From: david.distel@exeloncorp.com
Sent: Friday, February 25, 2011 11:56 AM
To: Jessie, Janelle; Hale, Jerry
Subject: Exelon Letter - Response to Hydrology Audit Information Needs Items 8, 52a, and 66
Attachments: NP-11-0009 - Hydrology Audit Information Needs Response Items 8, 52a, 66.PDF

NP-11-0009
February 24, 2011

Subject: Exelon Nuclear Texas Holdings, LLC
Victoria County Station Early Site Permit Application
Hydrology Audit Information Needs Response
NRC Docket No. 52-042

Figure 1. Elevation-storage relationships for Coletto Creek Dam based on SSAR Tables 2.4.3-10 and -11

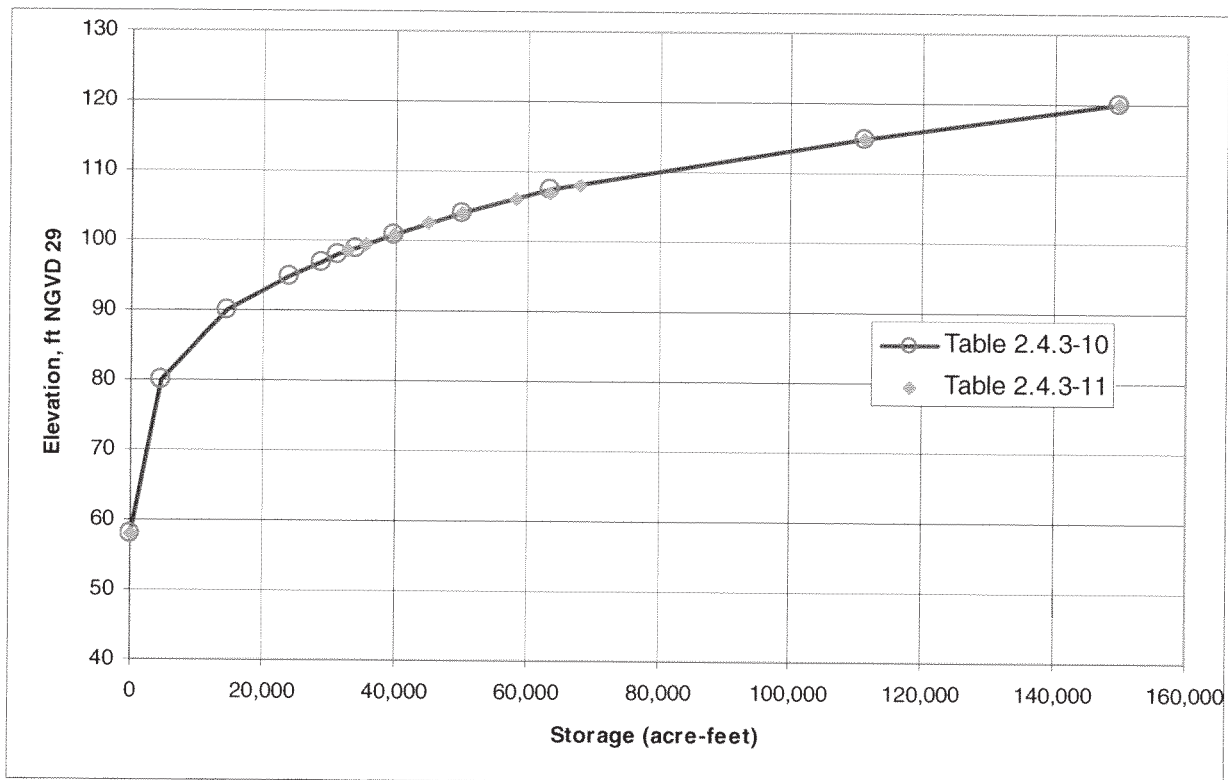
In the meeting, NRC also asked that clarifications be provided on two items: (a) an apparent discrepancy of about 10 percent in the Coletto Creek Dam/Reservoir elevation-storage relationships shown in SSAR Rev 0, Tables 2.4.3-10 and Table 2.4.3-11, and (b) the statements "*The elevation-storage relationships for the Coletto Creek Dam are slightly different from those given in Subsections 2.4.1 and 2.4.4. Since the impact due to these differences is expected to be minor, they are adopted in the VCS PMF model as given in the NWS RFS model.*" in SSAR Rev 0, Subsection 2.4.3.3, page 2.4.3-7.

As described in SSAR Rev 0 Subsection 2.4.3.3.1, the elevation-storage and storage-discharge relationships for the Coletto Creek Dam/Reservoir used in the PMF analysis for the Victoria County Station (VCS) site, as shown in the corresponding Tables 2.4.3-10 and 2.4.3-11, are adopted from the National Weather Service (NWS), River Forecast System (RFS) for Guadalupe River Basin (Reference 2.4.3-2). SSAR Table 2.4.3-10 listed the storage values for specific elevations from 58 to 120 feet NGVD 29 as given in Reference 2.4.3-2. SSAR Table 2.4.3-11, however, focuses primarily on storages above elevation 98.5 feet NGVD 29, which is the starting water level for the Coletto Creek Dam in the VCS PMF analysis (see SSAR Table 2.4.3-25). The additional elevation-storage values provided in Table 2.4.3-11 from elevation 98.5 to 108 feet NGVD 29 were derived by interpolation of the relationship in Table 2.4.3-10. The two elevation-storage relationships are compared graphically in Figure 1, which illustrates that there is no discrepancy in the elevation range of significance to the PMF analysis (above 98.5 feet NGVD 29).

As a result of the clarification to Item (a), the footnote for SSAR Rev 0, Table 2.4.3-11 will be revised as follows:

Source: U.S. National Weather Service River Forecast System for Guadalupe River Basin (Reference 2.4.3-2), with storage values interpolated from Table 2.4.3-10 (for elevations 98.5 feet NGVD 29 and higher).

Note: Elevations in Table 2.4.3-11 are given in terms of NGVD 29. To convert to NAVD 88, subtract 0.29 feet from the values shown in the table.
